Technical Service Bulletin

21 Rattling/jarring noise from engine - 2.0 TFSI EA888 transverse

21 13 15 2027585/4 June 24, 2013. Supersedes Technical Service Bulletin Group 21 number 12-09 dated May 16, 2012 for reasons listed below.

Figure 5. Fit the spring clip on the wastegate adjustment.

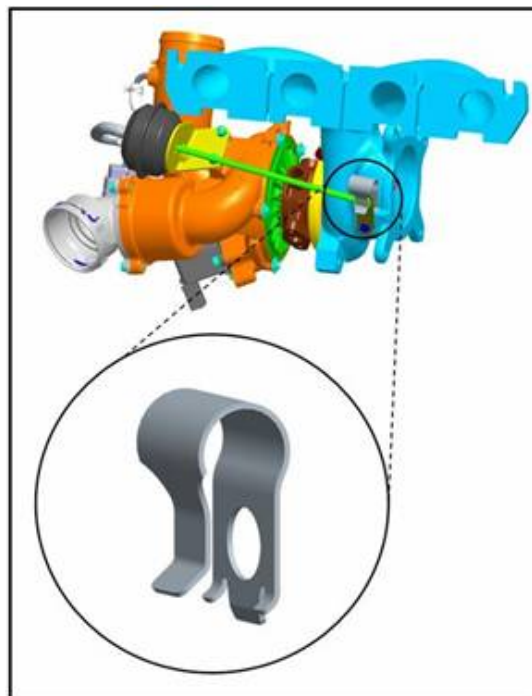
3. Fit the spring clip on the wastegate adjustment (Figure 5).

Tip: The spring tip must not be overstretched. The maximum opening of the spring clip is 14 mm. In the example in the image, the opening is approximately 10.5 mm (Figure 6).

The spring clip must be replaced after every removal.

Figure 7. *Spring clip correct fitting.*

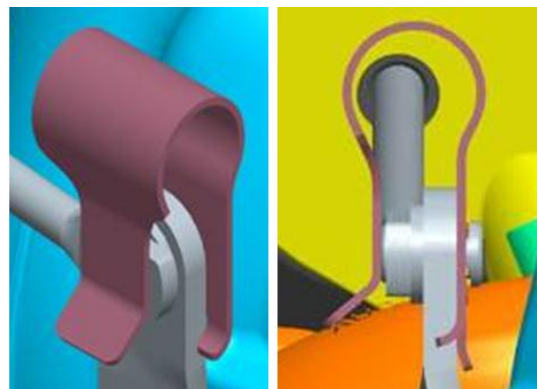
4. After fitting the spring clip, check for correct fit (Figure 7).
